TECHNICAL NOTE				VELOCITY4	
Client	Kitewood Estates Ltd.			Page No.	1 of 19
Project	Site A Willow Way, Sydenham			Project No.	22/089
Subject	Technical Note in Support of Planning Appeal			Document No	TN004
Prepared By	PM/AM	Checked and Authorised By	MK	Date	11 May 2023

**Table 1-1: LBL Officer Report Comments on the Application and VTP Response**

**Table 1-2: LBL Transport Comments on the Application and VTP Response**

Scale @ A3 <b>1:250</b>	Date <b>27/04/23</b>	Designed/Drawn <b>IZ</b>	Checked <b>AM</b>	Approved <b>MK</b>
Project Ref <b>4770-2001</b>	Drawing Number <b>4772-2001-T-004</b>			Rev <b>B</b>

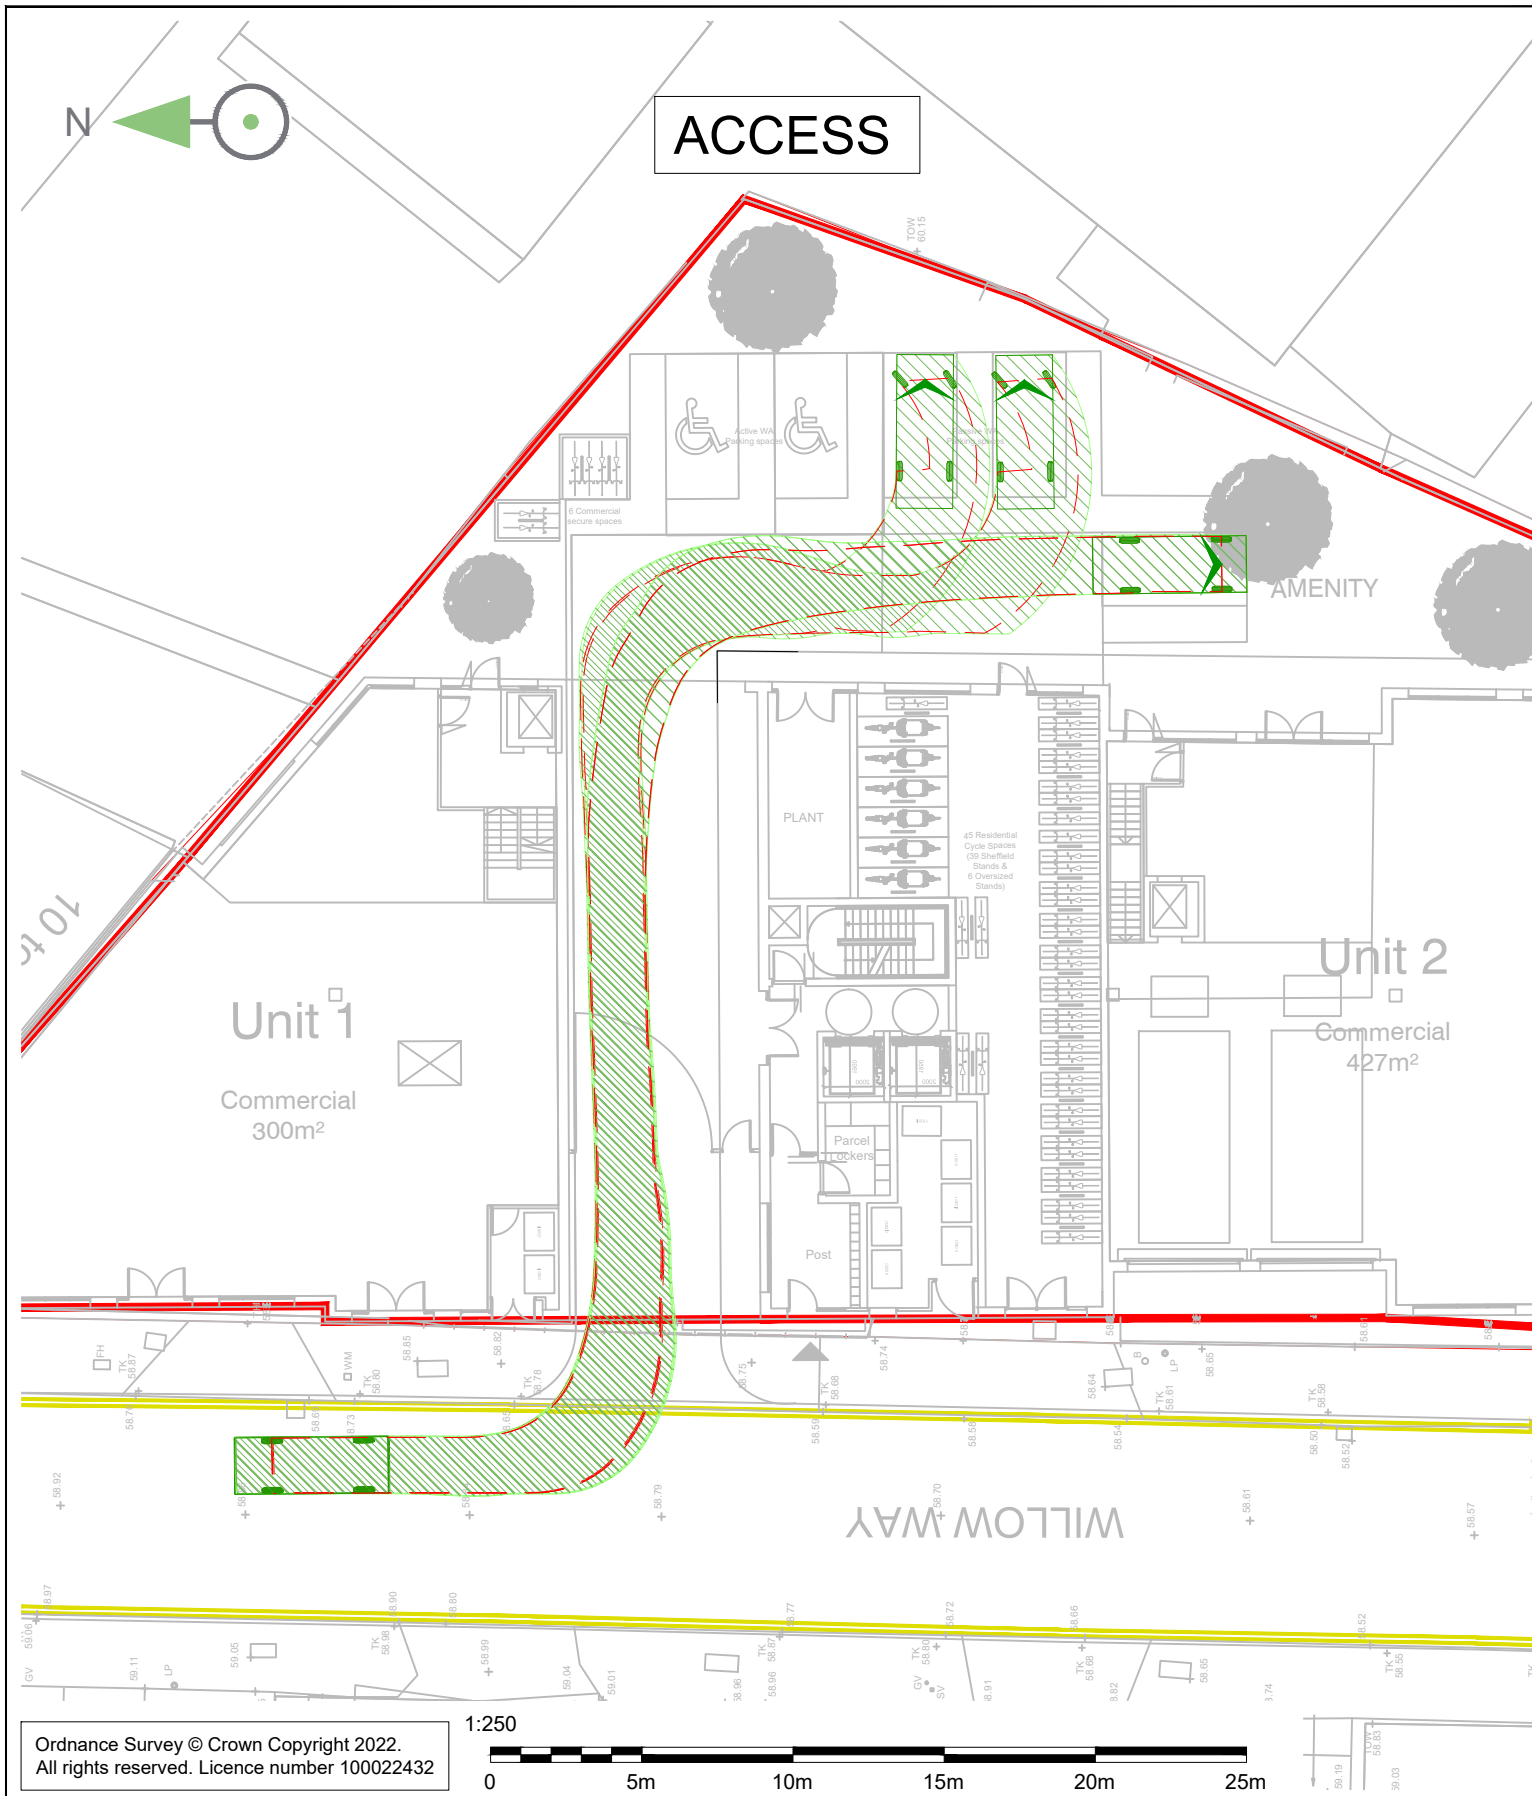
324	<p><b><u>Disabled Parking Spaces:</u></b></p> <p>The application omits one disabled parking space associated with the commercial proposals for staff or visitors. Policy T6.5 non-residential disabled parking stipulates access to at least one disabled parking bay (on or off street). This will need to be addressed.</p> <p>The application should also be accompanied with swept paths of a large vehicle accessing parking and egressing the site which has not been provided.</p>	<p>It is accepted that a specific disabled parking space for the commercial element has been omitted as part of the application. Given the proposals include safeguarded space on-site to accommodate an extra 3 disabled parking spaces, it is considered that one of these spaces could be allocated to the commercial element in the first instance.</p> <p>An additional on-street space could be provided (within the public highway, and therefore outside of the application boundary) in order to maintain the safeguarded provision for 10% of the residential units to have a disabled parking space. This could be provided as part of the TRO process, should it be required.</p> <p>As the number of blue badge holders within Lewisham's population is around 2% (DfT Statistics, Table DIS0109, 2016 data), it is considered highly unlikely that there will be demand by residents for use of all six disabled bays proposed in the application. Blue badge holders in Lewisham can also park on single or double yellow lines for up to three hours where loading/unloading is permitted (Section 4.3 of LBL Parking Policy, March 2023) meaning any demand by visitors can reasonably be accommodated on-street.</p>

PARAGRAPH	PLANNING OFFICER / LBL HIGHWAYS COMMENT	VTP RESPONSE
		<p>The revised approach is therefore considered to be acceptable within the constraints of the site.</p> <p>It is anticipated that access to the rear parking court will only be permitted to standard sized service vehicles in exceptional circumstances such as plant needing maintenance. The rear parking court was therefore designed primarily to accommodate movements of cars.</p> <p>Swept path analysis shown in <b>APPENDIX F</b> demonstrates that large cars can access and egress all parking spaces adequately.</p>
325	<p><b>Electric Vehicle Charging Infrastructure:</b> 20% of the disabled bays should be EV ready with 20% passive provision. This equates to one disabled space with an EV charging point and one passive space. This will need to be shown on the plans and secured by condition.</p>	<p>It is noted that the proposals set out within the application propose to exceed this provision by providing two active charging spaces from the outset. However, the Applicant will achieve this requirement in any case.</p>
